September 25, 2009
Final Report
Expedited System Impact Assessment
Hydro One Networks Inc.

This addendum updates the System Impact Assessment (CAA ID 2007-260) originally issued on October 8, 2008 for the new transformer station Rodney TS. Please refer to the original System Impact Assessment report for the assessment details.

Duart TS (Rodney TS) – Transformer Station
CAA ID # 2007-260 - Addendum

Figure 1: Modified Connection Arrangement

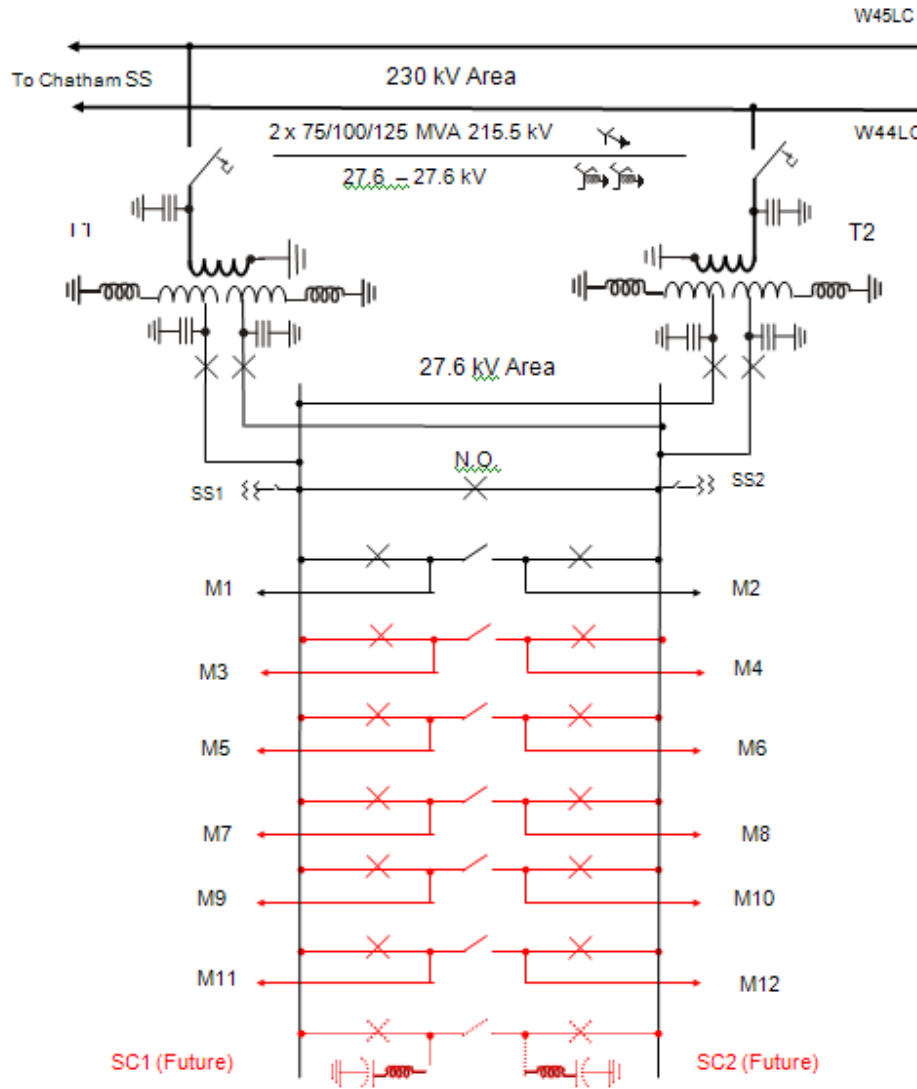
Hydro One has since updated its specifications and will install two 75/100/125 MVA 215.5/27.6/27.6 kV three-winding transformers at the station with a new in-service date of December 31, 2011.

Figure 1 shows a diagram of the proposed modified connection arrangement. Initially when the station is to come in-service, two feeder breakers would be installed along with one feeder tie-switch. As load in the station grows, additional feeders, feeder breakers and feeder tie-switches will be installed. Up to ten additional feeder breakers and five additional feeder tie switches can be accommodated at Duart TS. The specifications provided for the transformer, bus tie and feeder breakers corresponding to this modified connection arrangement have not changed from what was previously provided for the original assessment.
